DA 130/2019/DA-SL- RESPONSE TO REQUEST FOR ADDITIONAL INFORMATION - 247 JAMBOREE AVENUE, DENHAM COURT

Table 1 – Response to request for additional information

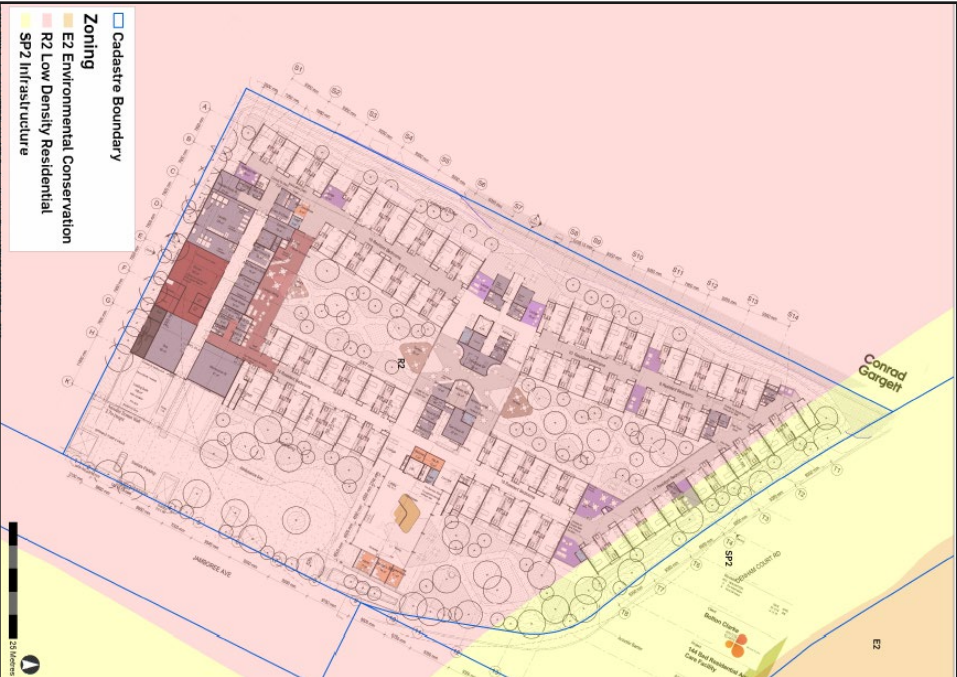
| Matter for consideration | Response |
|---|---|
| <ul style="list-style-type: none"> ○ the proximity of the car park to the street and lack of landscape screening ○ the large setback between the building and Jamboree Ave ○ the visual prominence of the loading dock, acoustic screen, pump room and substation ○ the design of the street front fence - lack of architectural design, material consistency and street front planting ○ - the lack of regard to the Seniors Living Urban Design Guidelines | <p>The car park and associated services within the Jamboree Avenue setback have been redesigned to address Council's concerns. In this regard, the existing 8 visitor spaces have been reduced to 4 spaces and the substation and fire sprinkler pump that were original on the eastern boundary, have been relocated, away from the streetscape. The loading dock has been designed to integrate with the façade, noting that this is substantially setback from the streetscape and is screened by the proposed mature trees, as illustrated in the below excerpt:</p>  <p>The amended landscaping plans provided at Attachment B confirms that the proposed street fence is well integrated into the landscaped setting of the site and provides for visual interest within the streetscape.</p> |
